Meeting Minutes (Final)

Prepared for: Vista Irrigation District
Project Title: Flume Replacement Alignment Study
BC Project No.: 156443

Purpose of Meeting: DDW Engagement Meeting #2
Meeting Location: Teams/Virtual
Minutes Prepared by: Phoebe Strauss, Brown and Caldwell (BC)

Meeting Date: August 7, 2024
Time: 2:00 - 3:00 p.m.

Steady-State: Minimum Pressures

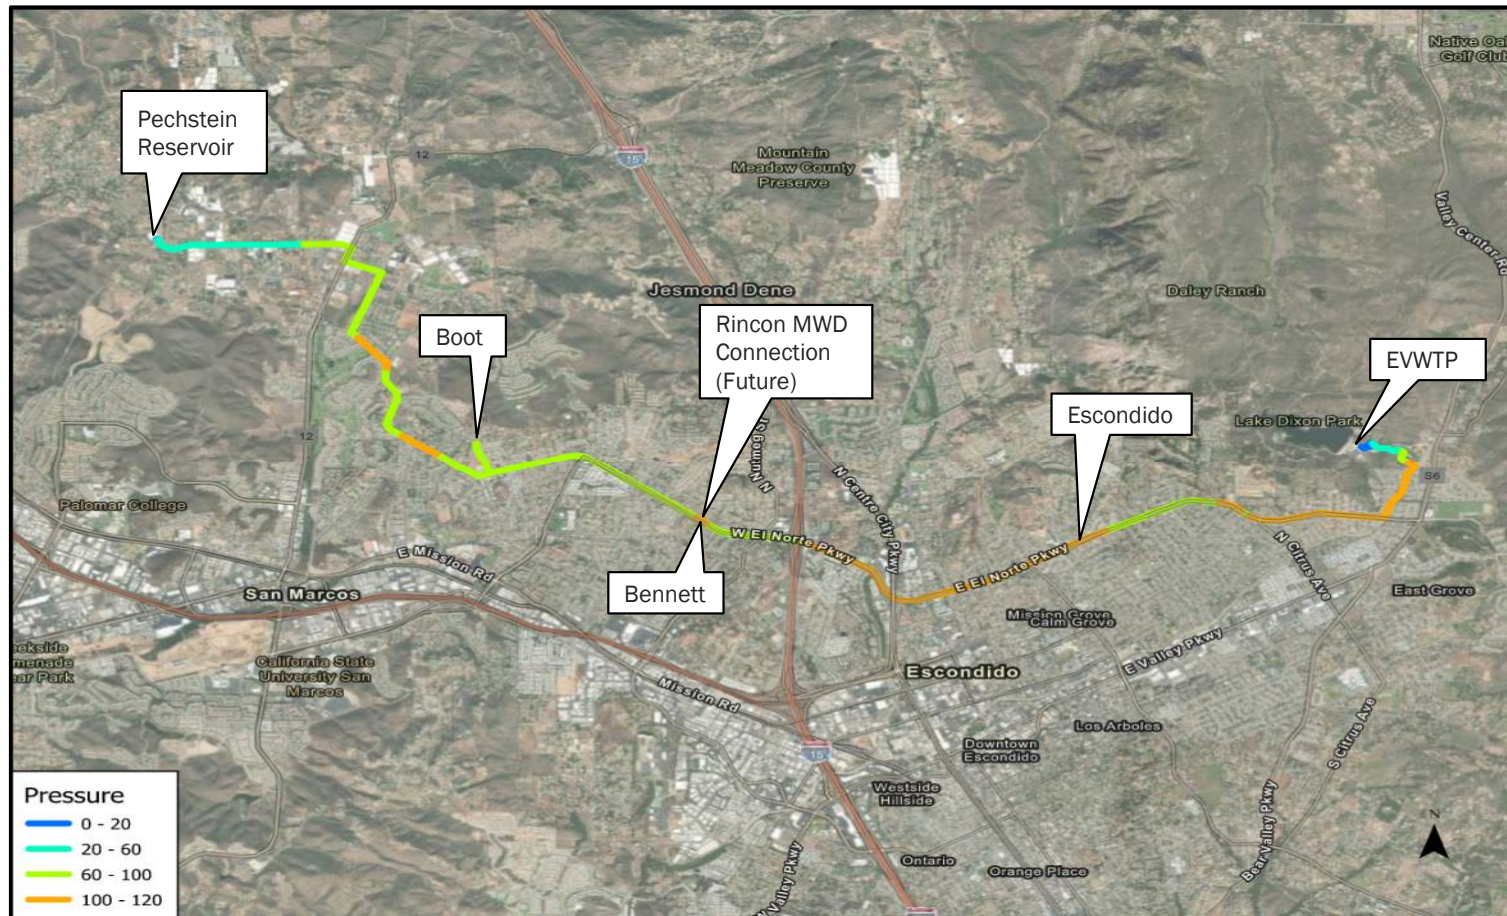
- ii. Implementation of surge best practices is important to DDW; important to include the downward facing elbow with screen on the CARV detail.
 - iii. Minimum pressure requirements: DDW note they take no issue with pressures < 20 psi within the agency property so long it is confined to within the fence-line.
